SERVICE ACTION: CHECKING THE SIGNAL WIRE AT POWER DISTRIBUTION BOX

This Service Information bulletin replaces SI B61 09 19 **dated June 2019**

G05 (X5 Sports Activity Vehicle)	G07 (X7 SAV)	G12 (7 Series Sedan)	G14 (8 Series Convertible)
G20 (3 Series Sedan)	G29 (Z4 Roadster)

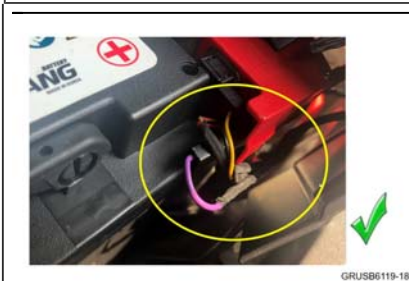
Connector (circled) shown not plugged in.

Connector (circled) plugged into the Battery Safety Terminal.

Note: Photo shows a G20. Other models may be slightly different.

For G12, G14, G20 and G29:
 Check the signal wire in the luggage compartment under the luggage compartment cover for correct installation.
 • If the signal wire is not plugged in, assemble correctly.

1. Disassemble the storage tray in the luggage compartment under the luggage compartment cover.
 2. Check the signal wire for correct installation.
- If the signal wire is not plugged in, assemble correctly.
